SOUTHWEST BIKEPATH CULVERT REPLACEMENT AT WAITE CIRCLE - 2019

CITY OF MADISON, WI

CITY PROJECT NO. 8466

ADDENDUM 1
8/29/19
CHANGED ENTIRE
DRAWING

DRAWING NUMBER
G-2
SHEET NUMBER
3 OF 25

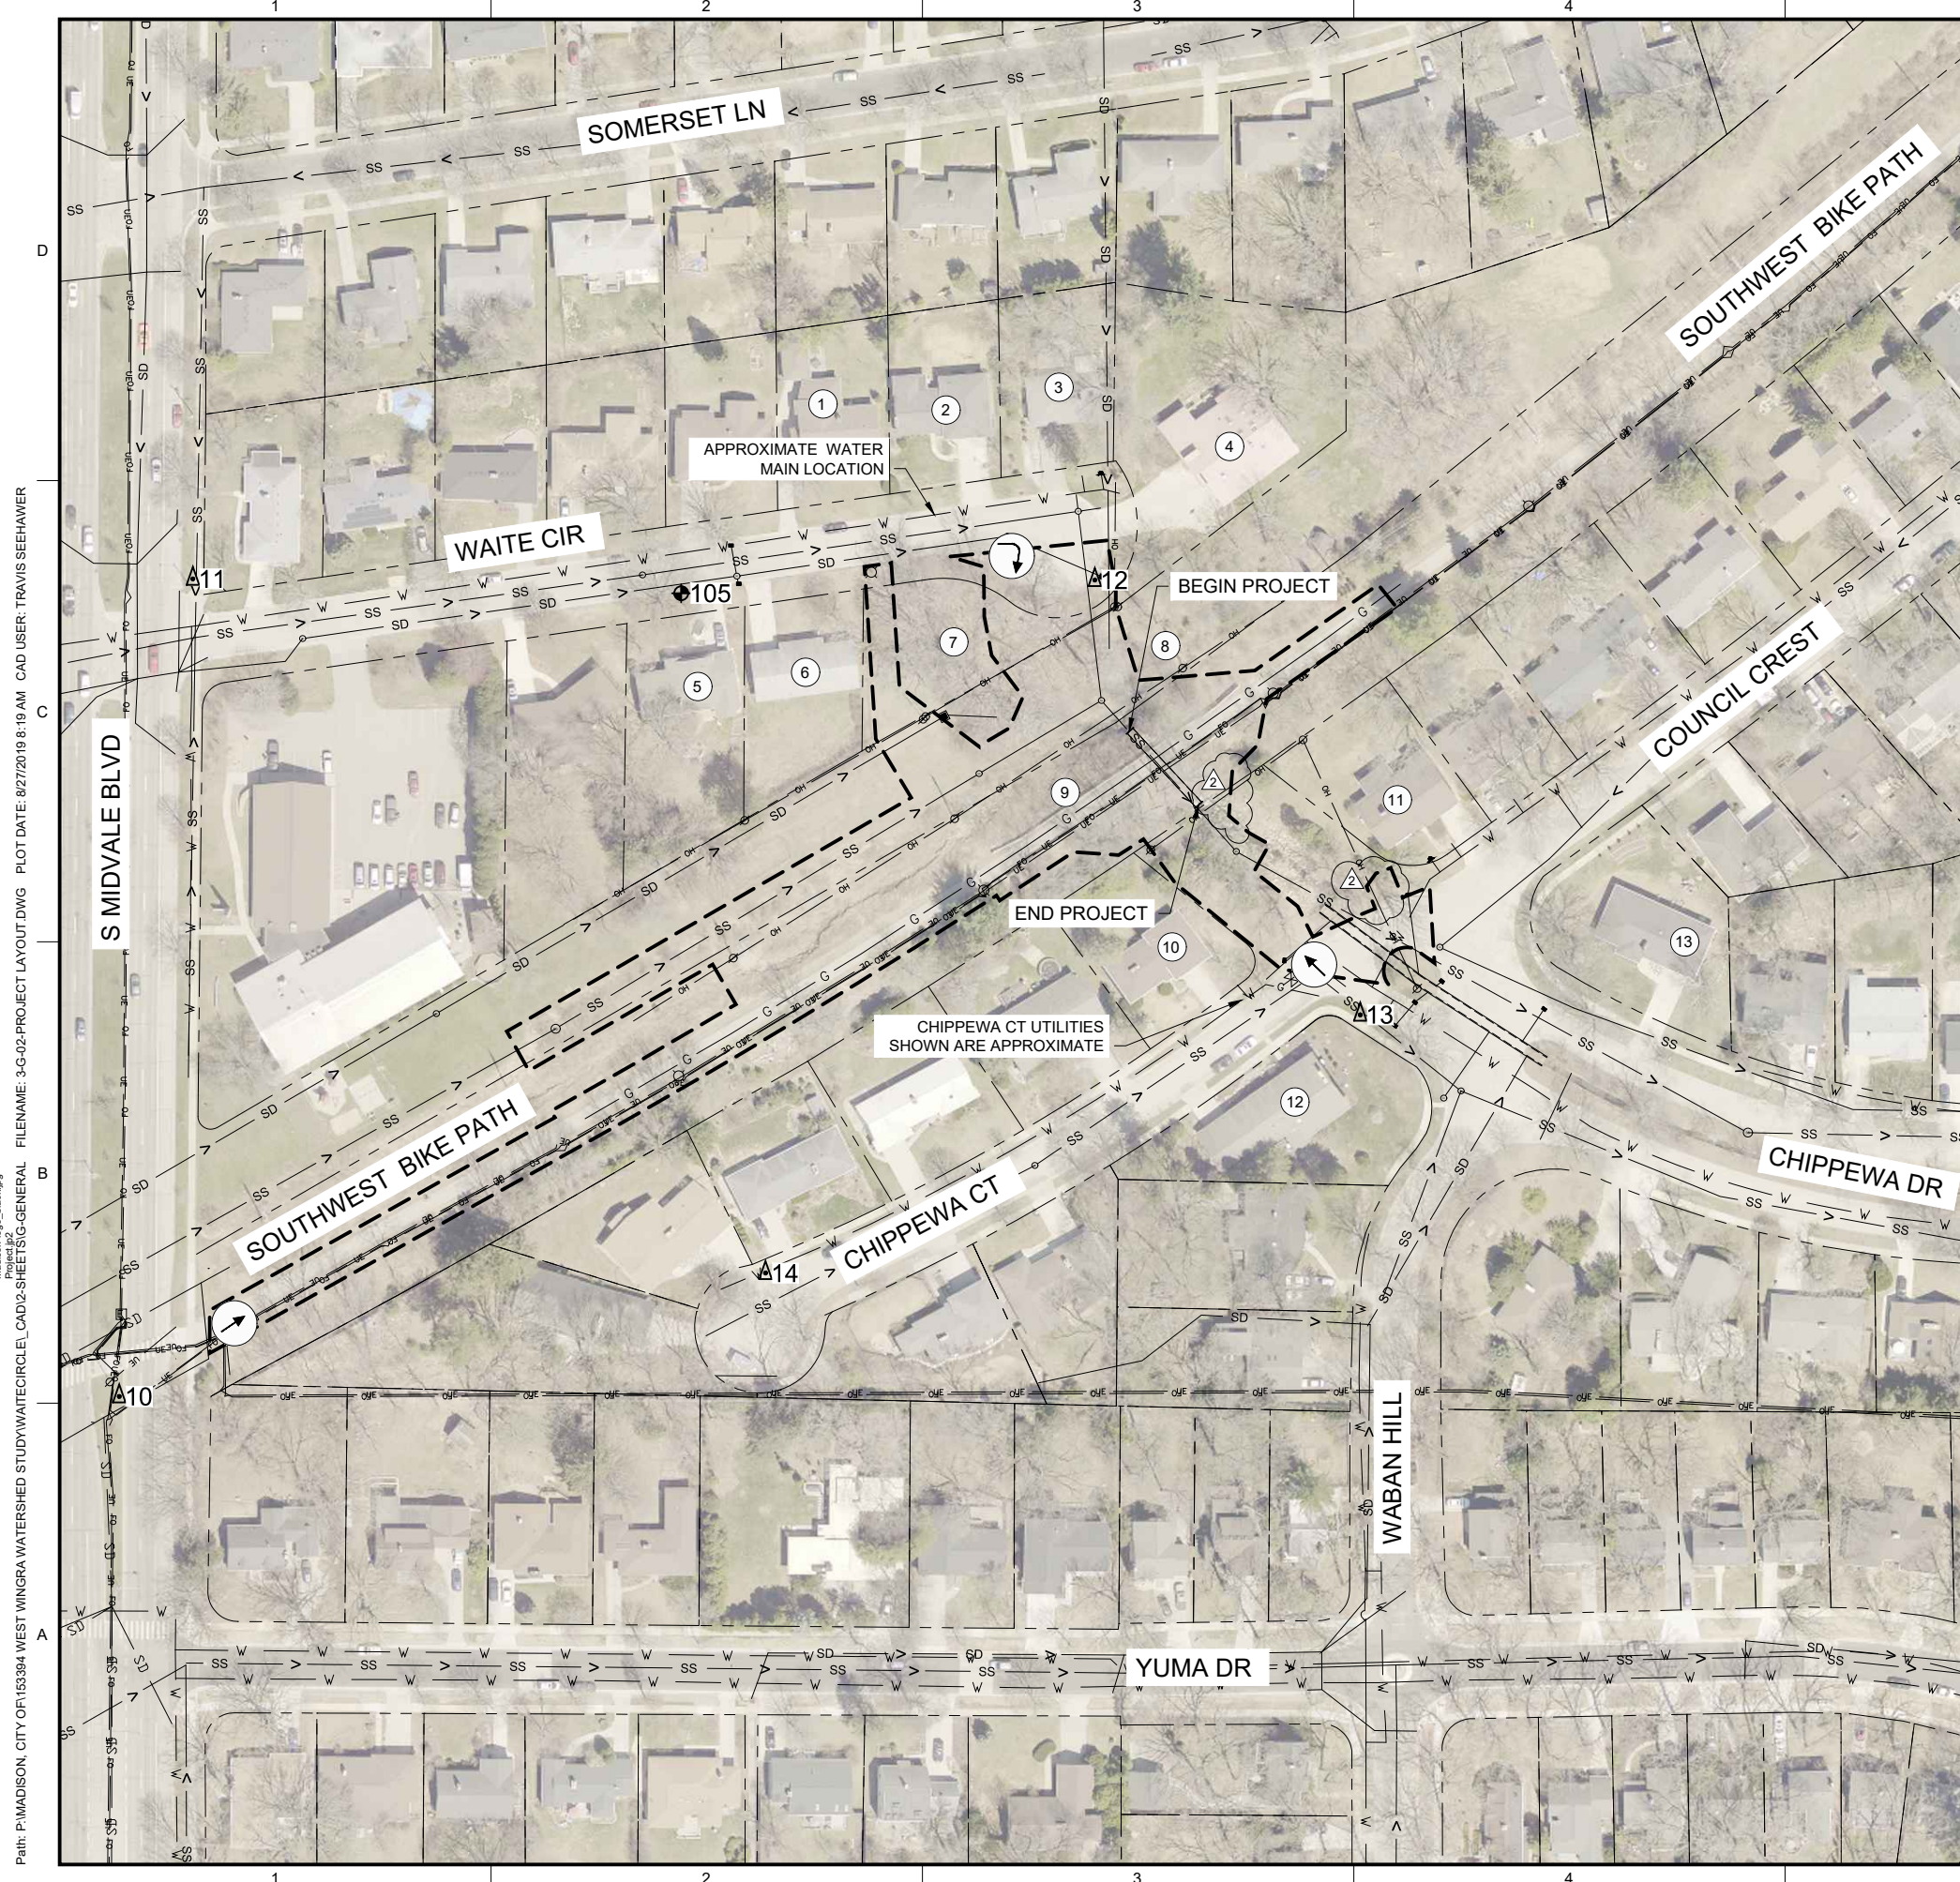
**ADDENDUM 1
CHANGED
CONSTRUCTION
LIMITS**

DRAWING NUMBER
C-1
 SHEET NUMBER
 6 OF 25

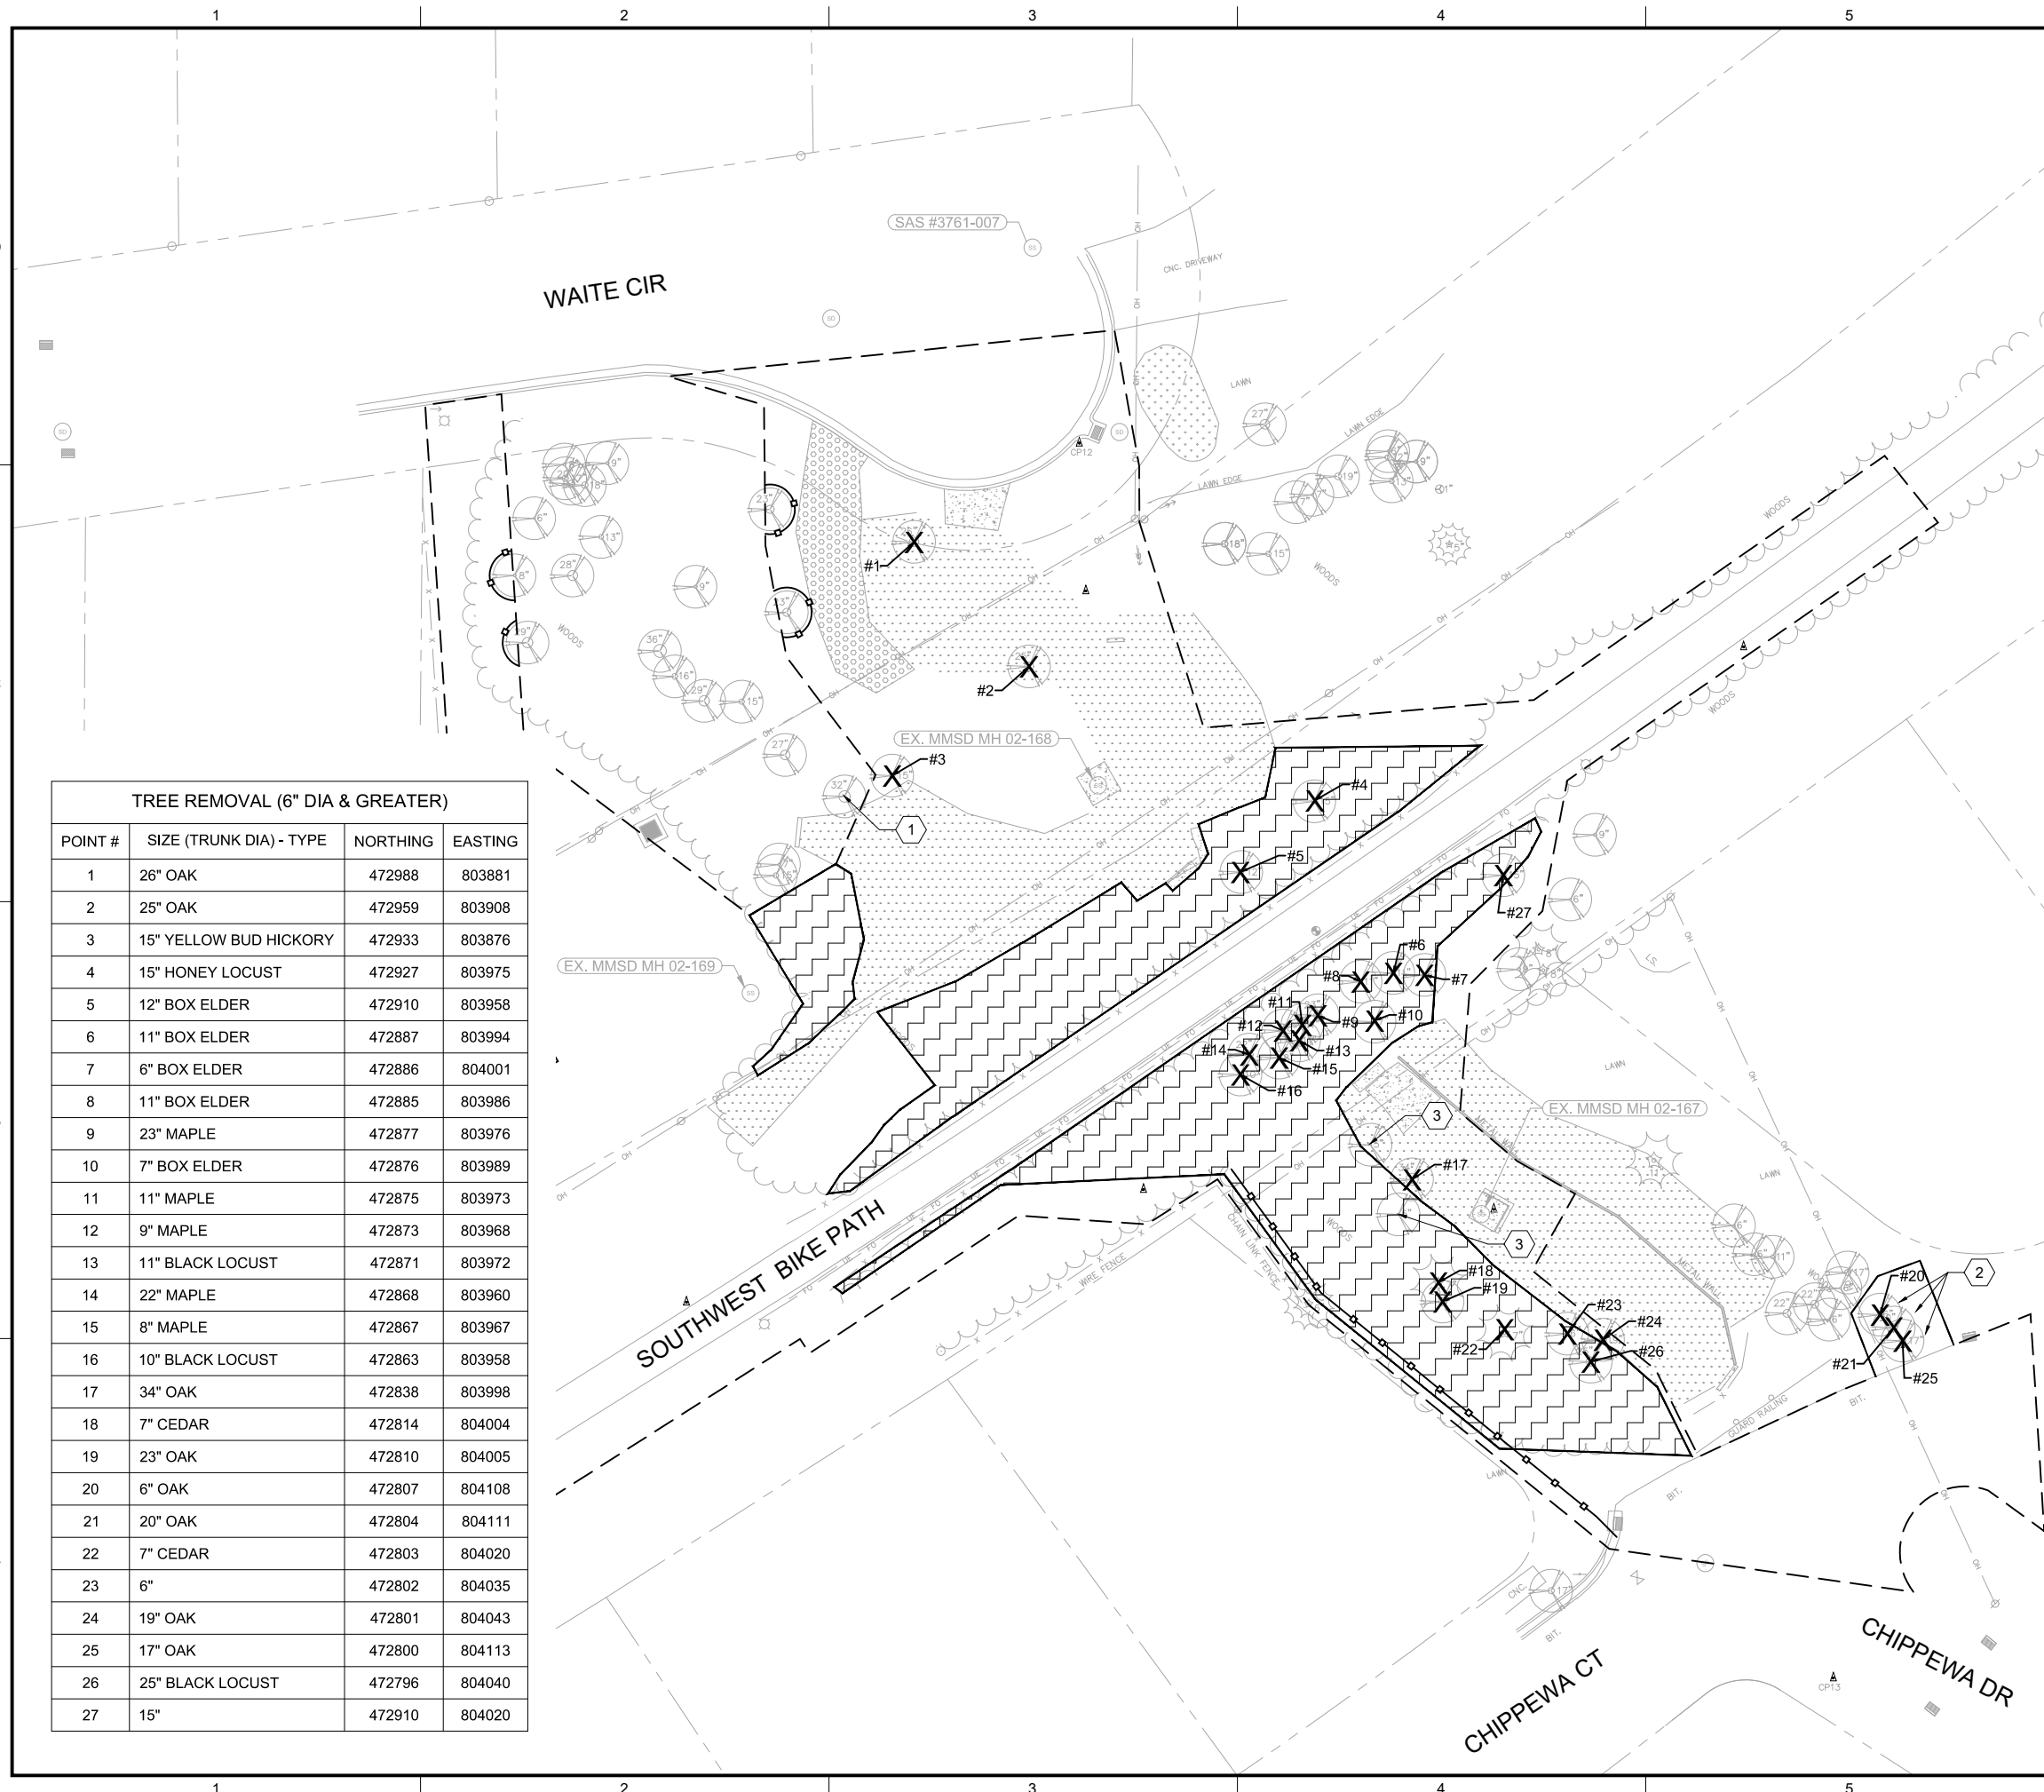
**ADDENDUM 1
CHANGED
ENTIRE
DRAWING**

DRAWING NUMBER
C-2
 SHEET NUMBER
 7 OF 25

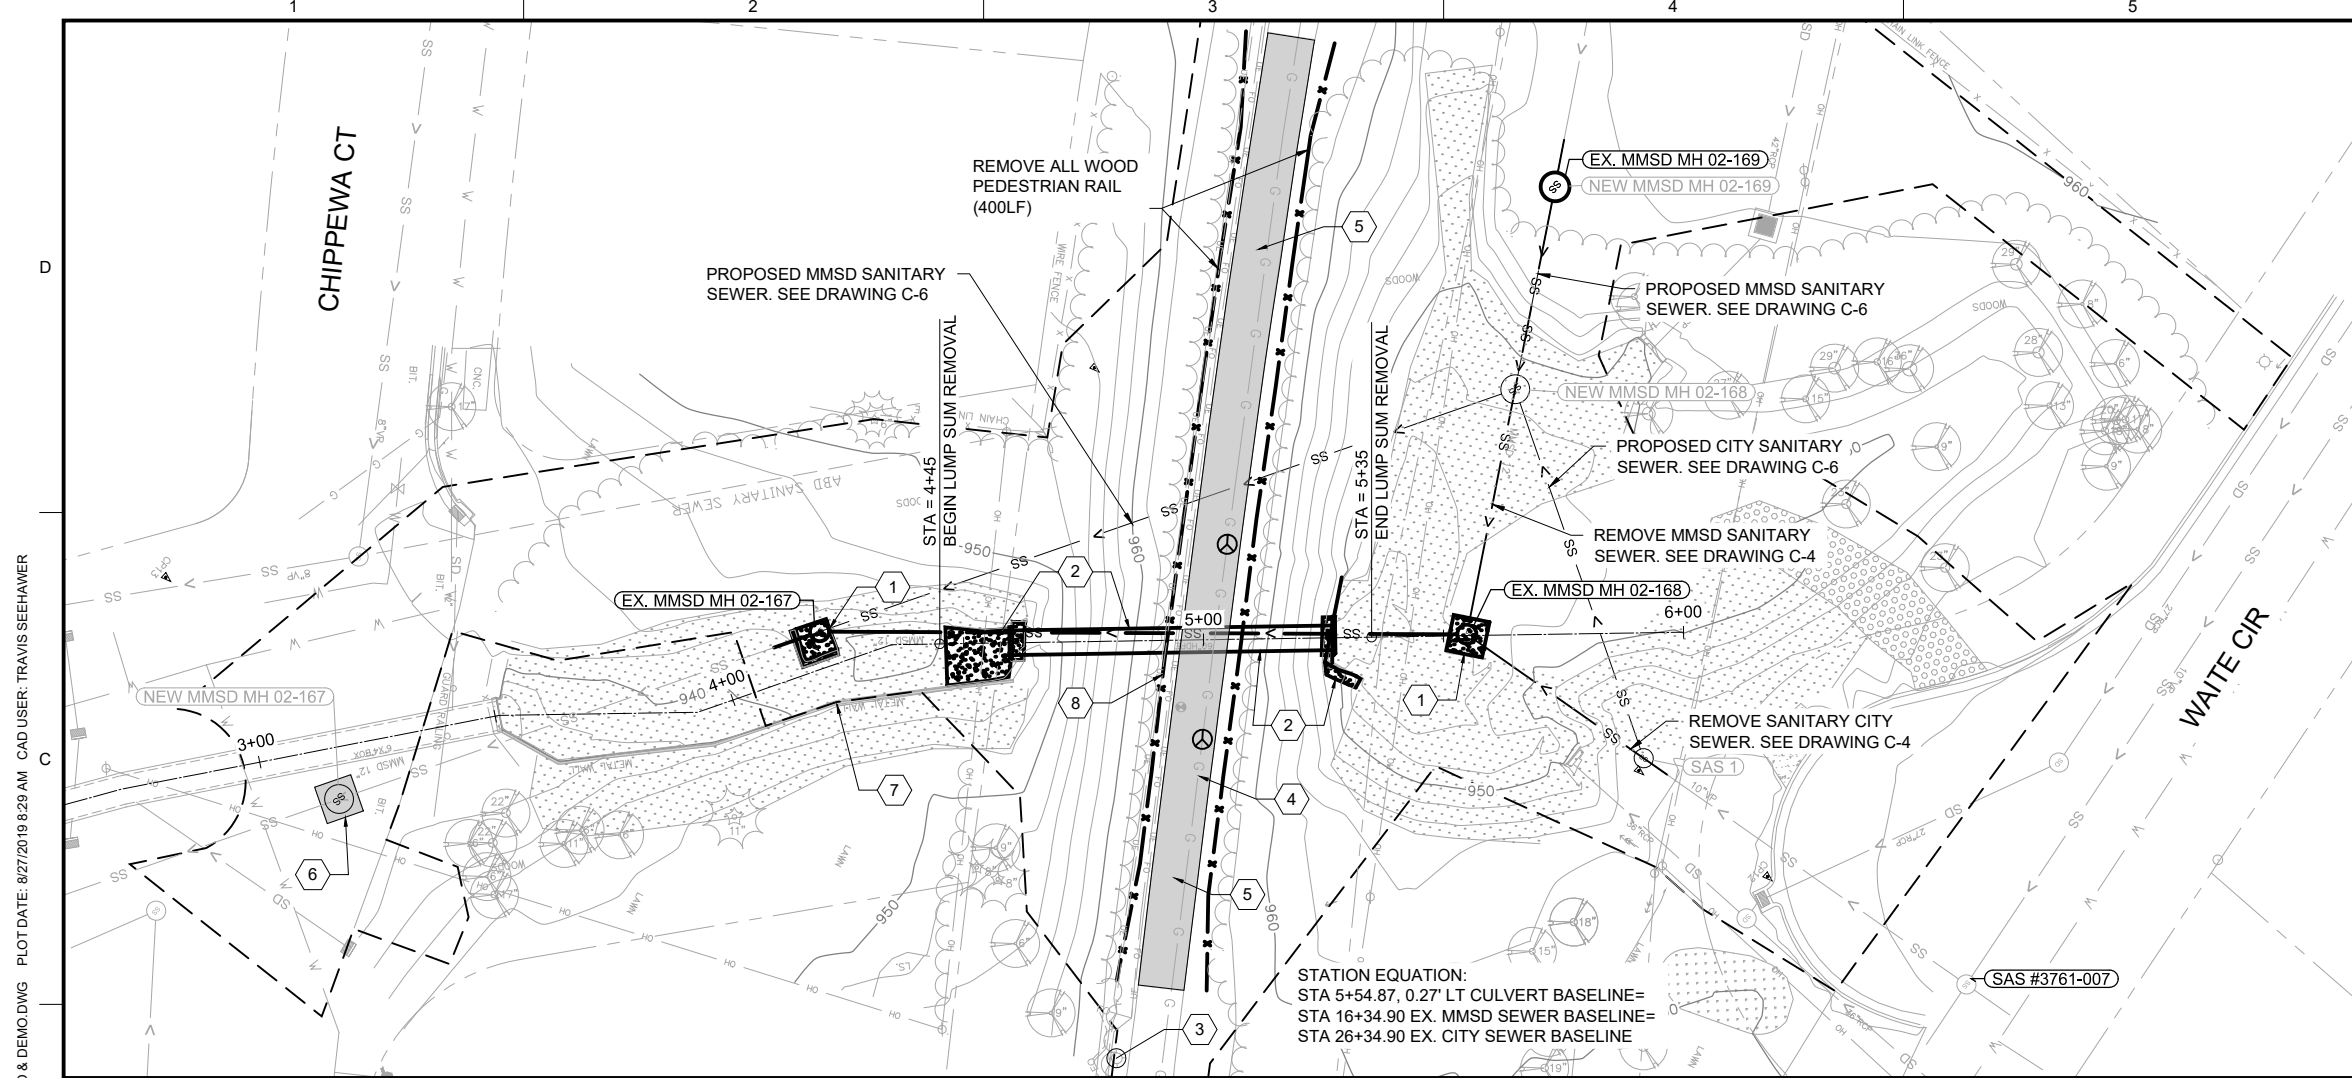
**ADDENDUM 1
CHANGED
ENTIRE
DRAWING**
